MAUCH CHUNK LAKE DAM

PHASE I INSPECTION REPORT
NATIONAL DAM INSPECTION PROGRAM

SEPTEMBER 1978

MAUCH CHUNK LAKE DAM
CARBON COUNTY, PENNSYLVANIA
NATIONAL I.D. NO. PA 00605

SEEPAGE LOCATION PLAN
MAUCH CHUNK LAKE DAM

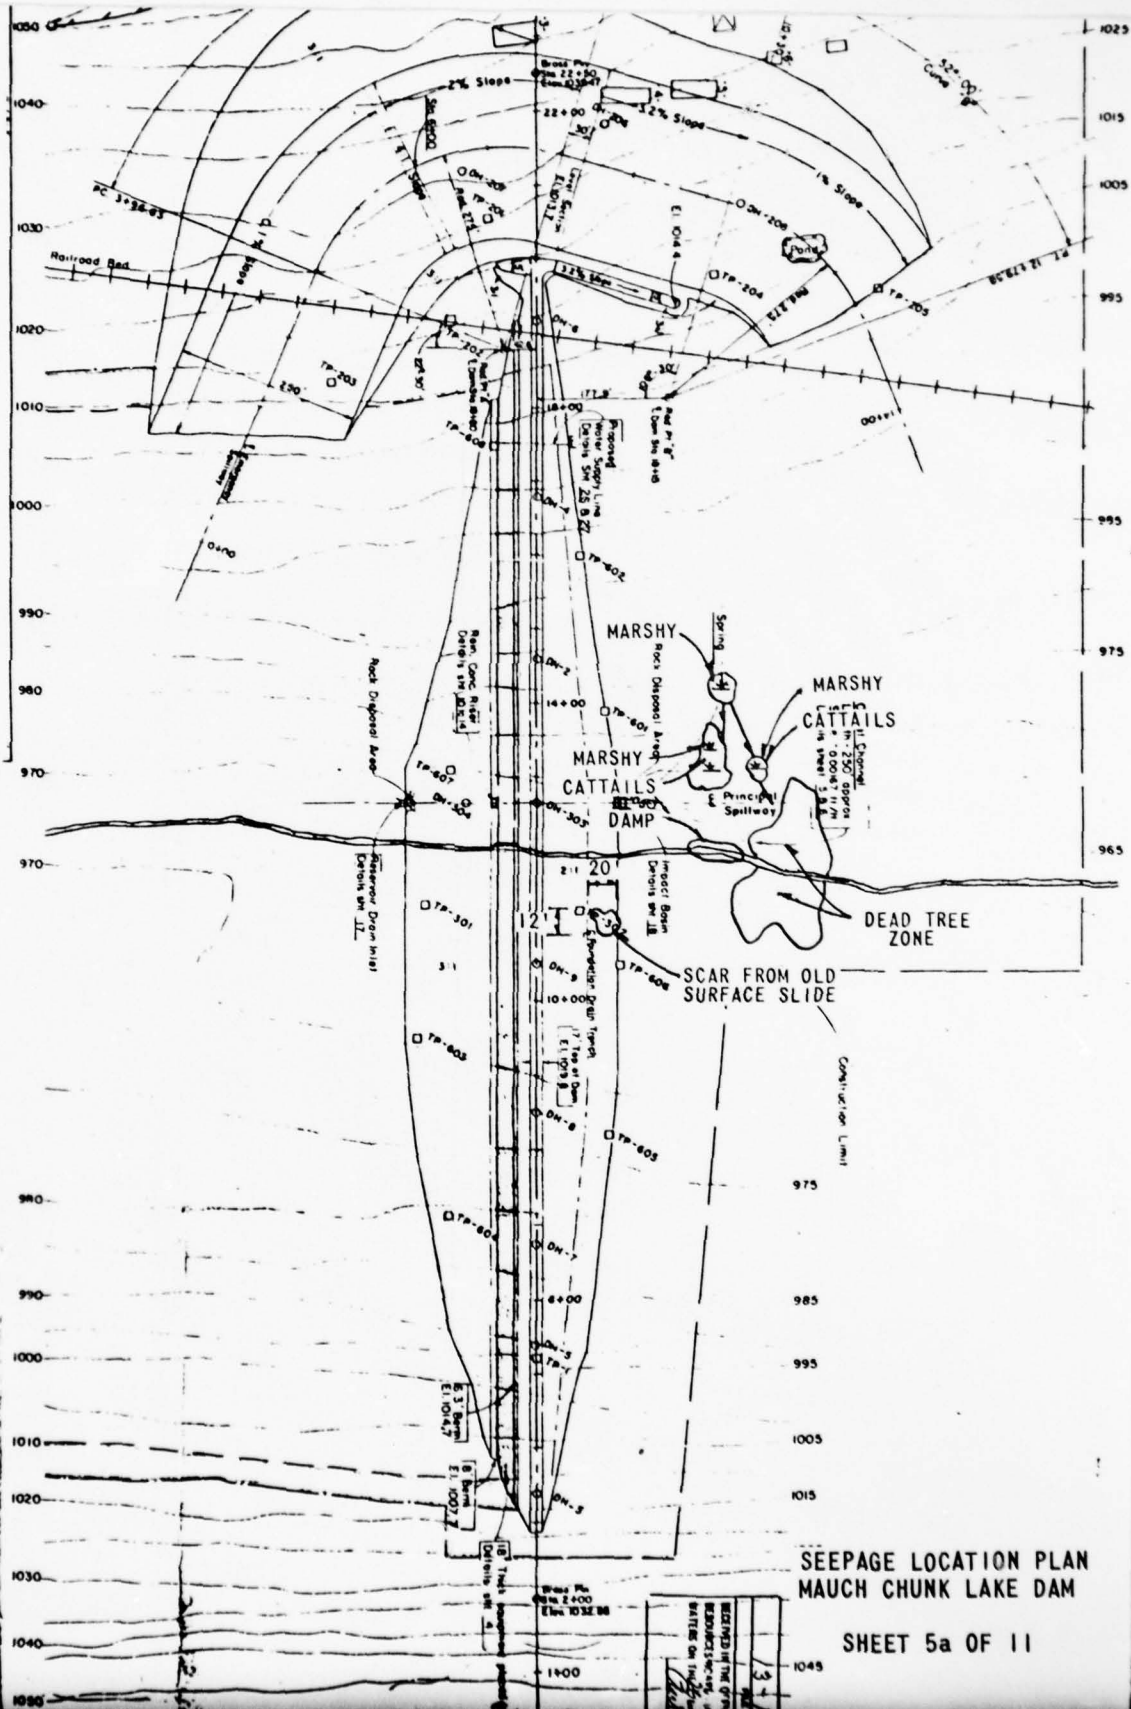
Since the filling of the reservoir, a wet zone has emerged approximately 300 feet downstream from the impact basin. This zone, as shown on Sheet 5a, is delineated by an area of dead trees. *Original geologic and soils investigation disclosed the flood plain to be a swamp and there were many springs on the abutments. Field permeability tests in test holes on the left side of the flood plain indicated permeability rates in the range of 60 feet per day through highly fractured and jointed sandstone. Therefore, this seepage and marshy area could have developed as a result of the hydrostatic forces from the reservoir. Park personnel reported that the marshy zones located to the left of the discharge basin have remained unchanged since construction.*

Further downstream, a zone of dead trees was noted. See sheet 5a of 11, Appendix B. The surrounding ground is marshy and presently contains some cattails. It is assessed, based on the visual inspection, construction photographs, and discussions with Park representatives, that this zone probably developed since filling of the reservoir. Therefore, this area should be carefully monitored for changes in flow rates or turbidity.

1. The marshy areas located to the left of the principal spillway discharge channel should be graded and drained. Discharge should be periodically collected and checked for changes in flow rates or in turbidity.

2. The marshy area designated by an area of dead trees downstream of the principal spillway should be monitored periodically for unusual changes in seepage. Considering the extent of this area, it is impractical to collect the water and check for flow rates. However, the area should be checked for concentrated flows and unusual changes in seepage rates which may lead to piping.

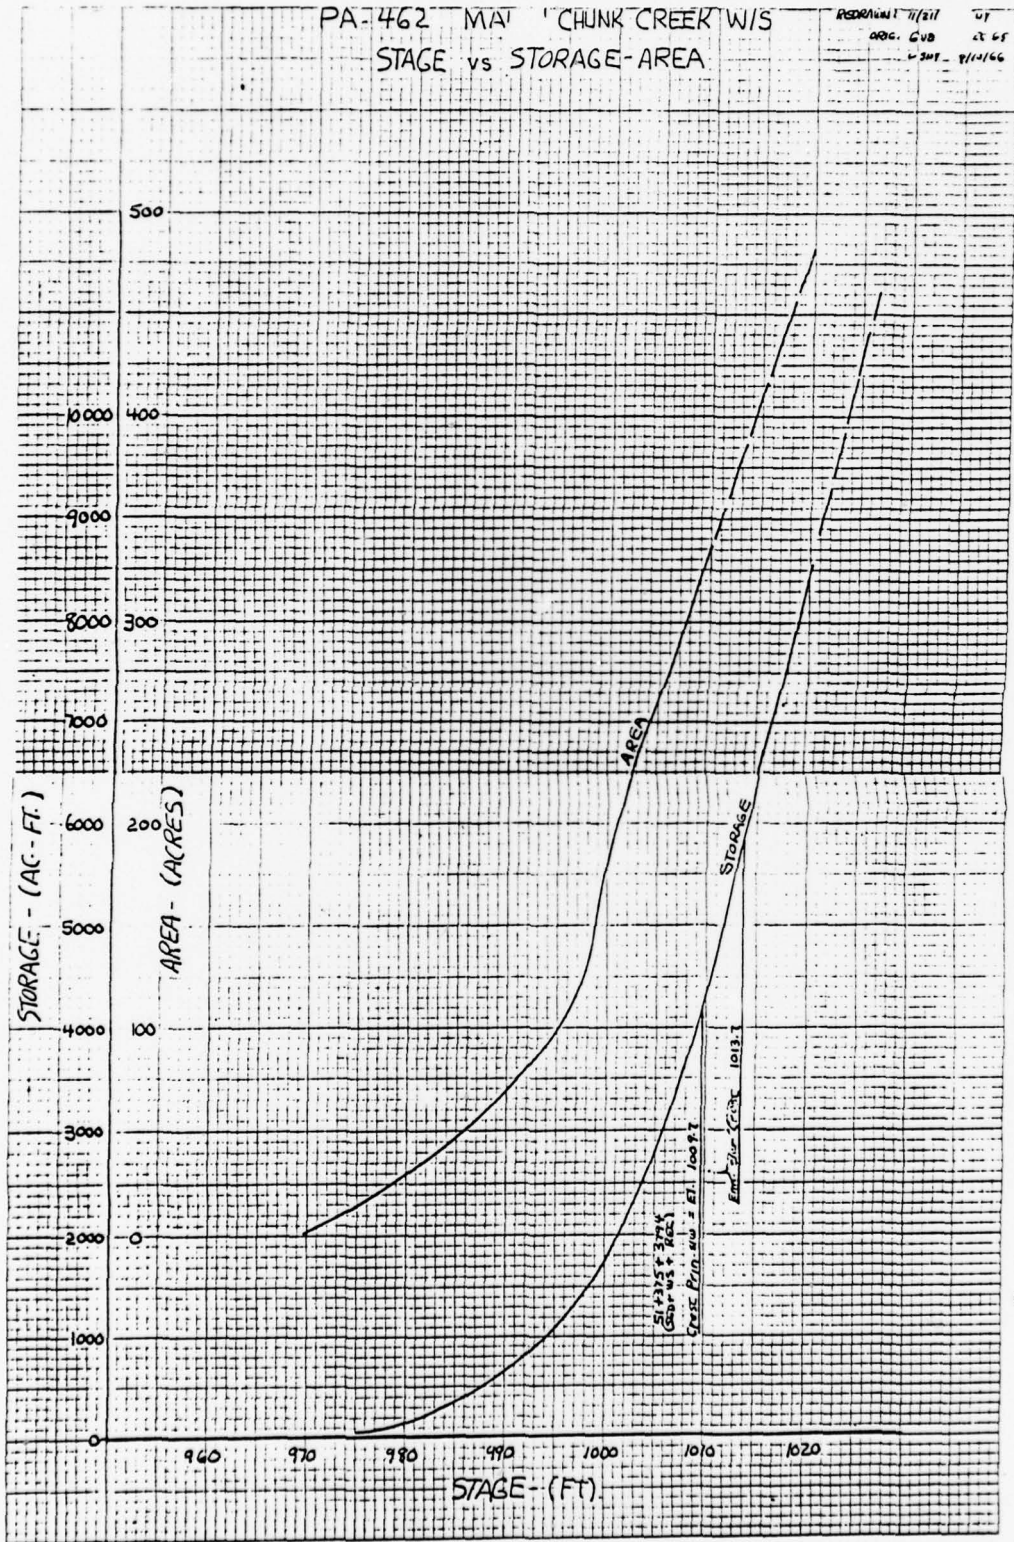
Emergency spillway discharge calculations.
 The original calculations were based on a bottom width (b) of 250 ft a z (side slope) of 2. The construction drawings indicated b = 250 ft and z = 3. Field check indicated b = 246 ± ft and z ~ 3. As shown on sheet 10, the difference in discharge is negligible.

1021.5	7.30	60	4.85	259.70	15,582	15,522	15,763	92.30
<p>Note: bottom width 'A' field checked to be 246 ± feet z = 3 on construction plans and the spillway side slopes appear to be constructed 5H:1V</p>								
<p>Therefore, the difference in discharge is negligible</p>								
<p>MFB 8/31/78</p>								
<p>0.6% difference</p>

PHOTOGRAPH NO. 9

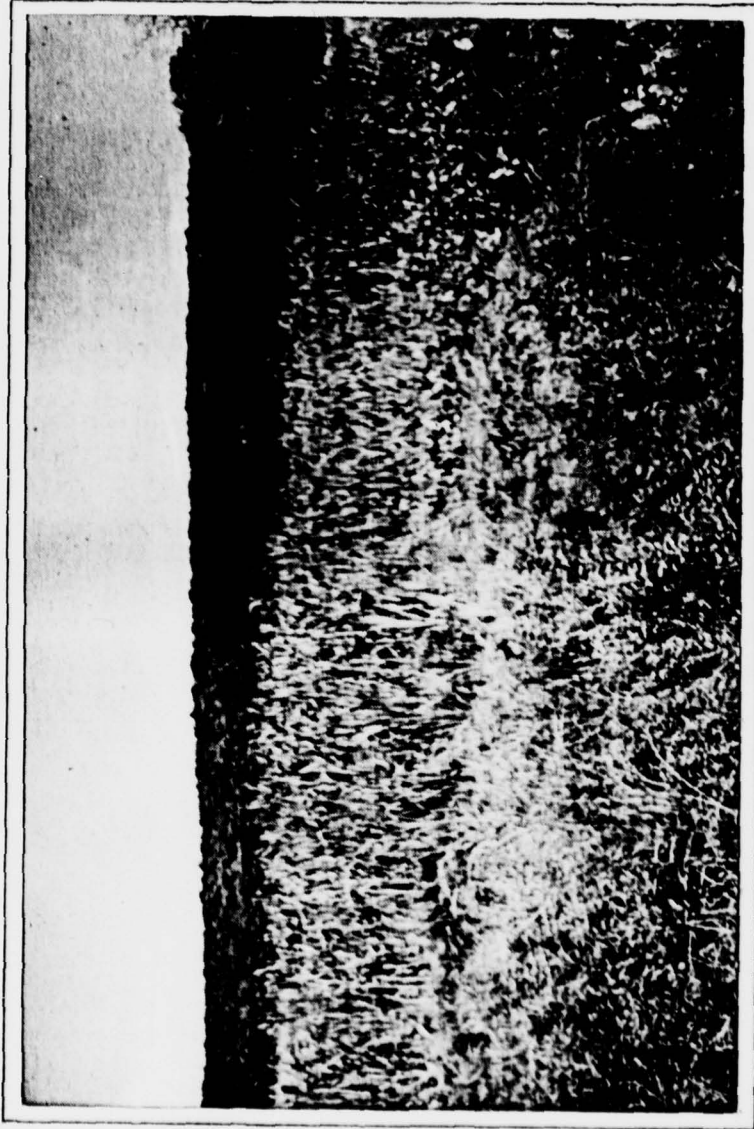
VIEW OF CATTAILS DENOTING SEEPAGE
ZONES. SEE SHEET 5a, APPENDIX B
FOR LOCATIONS.

CLOSEUP OF SEEPAGE SOURCES WITHIN
MARSHY AREAS DOWNSTREAM OF DAM.
SEE SHEET 5a, APPENDIX B FOR
LOCATIONS.
